Georgetown Charter Township

Planning Commission Meeting Agenda

Revised preliminary development plan for 44th St./8th Ave. PUD

(PUD0603C) Great Lakes Convenience, Inc., 6785 Whitneyville Rd. SE, Alto, is requesting revised preliminary plan approval for a PUD (not the PUD rezoning because it is already in place) (the application for the second final development plan to be subsequently submitted) for a gas station/convenience store, retail/bank building, drive-through restaurant and three apartment buildings on a parcel of land described as P.P. # 70-14-26-200-077, located at 850 44th St., in a (PUD) Planned Unit Development district, Georgetown Township, Ottawa County, Michigan.

enterprise gas & retail
gas station
pumps/ canopy

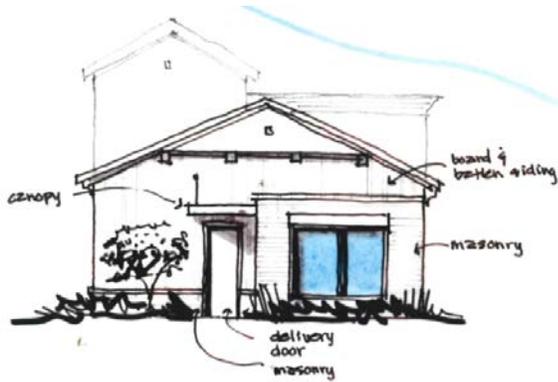
Proposed elevation of the gas pumps (in the minutes the Planning Commission stated that the flat canopy would be acceptable if located in the interior and if the building coordinated with the dental office building):

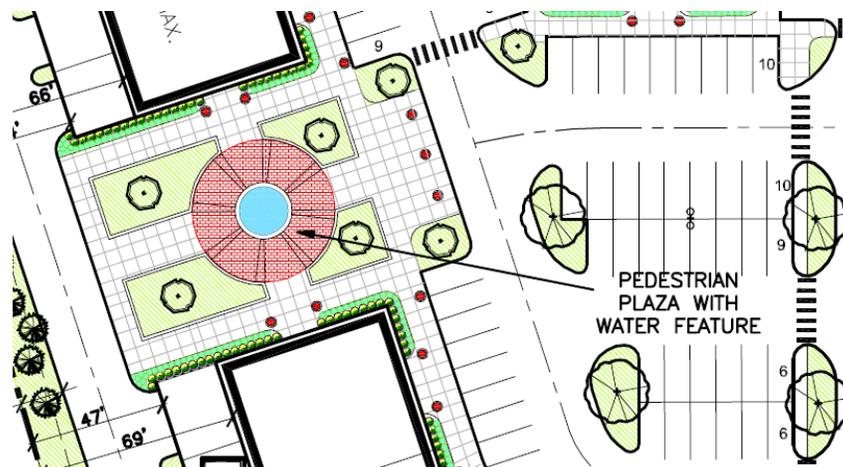
The Planning Commission will have to determine if this is met, along with whether the location of the gas pumps is acceptable. Does the proposal provide for safe and efficient vehicular and pedestrian movements within, into and off of the site?

The proposal appears to meet the stipulation of safe access into and off the site by making use of the two external driveways. The Planning Commission had directed that an interior service drive be provided and used to access the pumps. They are to be easily accessible to both 44th St. and 8th Ave. via the interior service drive. Note that vehicles accessing the pumps from 8th Ave. would likely turn north at the aisle between Buildings B and C since this is the shortest route, which would result in conflicts with vehicles backing out of the parking spaces on the east side of Building B and on the west side of Building C. Does this proposal meet the stipulation stated by the Planning Commission?

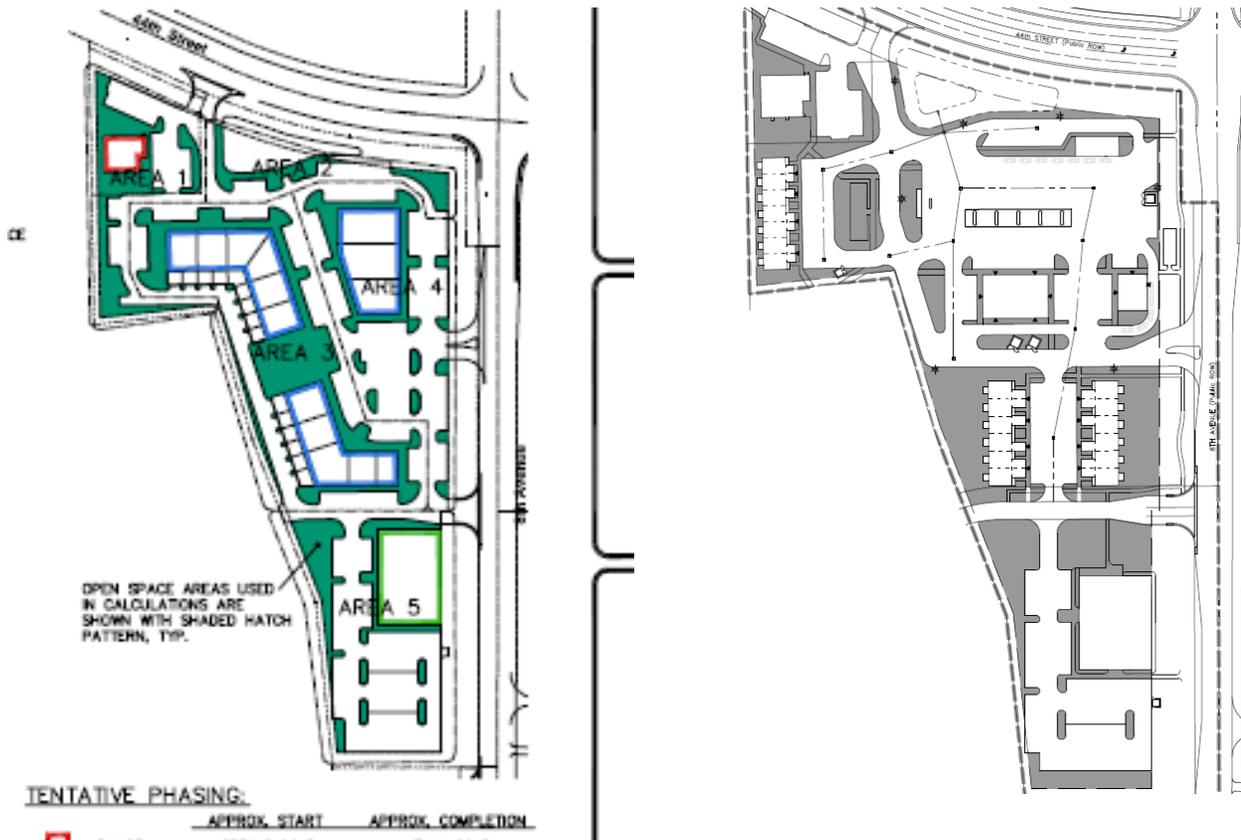
The previously approved preliminary plan indicated that there is 20% of open space as defined in the ordinance, which included a pedestrian plaza with water feature, along with greenspace and landscaping. This feature has been eliminated and landscaped berms and pedestrian plaza with benches has been added.

Below is the open space pedestrian plaza with water feature that was approved with the revised preliminary plan. This has been eliminated in the new plan.

Below on the right is the map of the previously approved open space with the pedestrian plaza with water feature. The map on the left is currently proposed.
